475 ECCLES AVENUE, SOUTH SAN FRANCISCO, CALIFORNIA
FINAL ENVIRONMENTAL IMPACT REPORT

SCH# 2012082101

RESPONSE TO COMMENTS
475 ECCLES AVENUE, SOUTH SAN FRANCISCO
FEBRUARY, 2016

RESPONSE TO COMMENTS 475 ECCLES AVENUE DRAFT ENVIRONMENTAL IMPACT REPORT (DEIR)

**FIGURE 3.2 EXISTING CONDITIONS 2013
2013 Building Demolished**

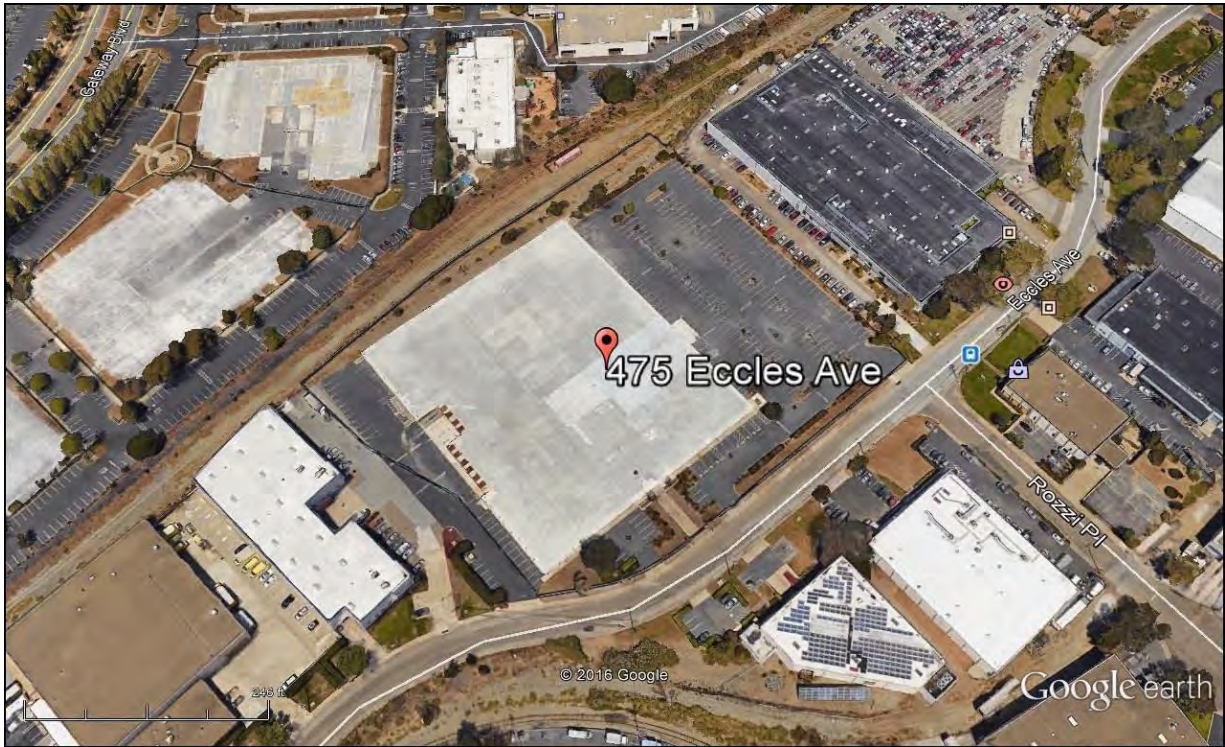
⁴ The site ~~currently~~ **was** developed with approximately 152,145 square feet of building area consisting of ground floor and mezzanine areas in **2012. The building was demolished in December, 2013 with City permits.** The analysis contained in the initial study rounded up to 155,000 square feet for geology, hydrology, air quality and other impact analyses.
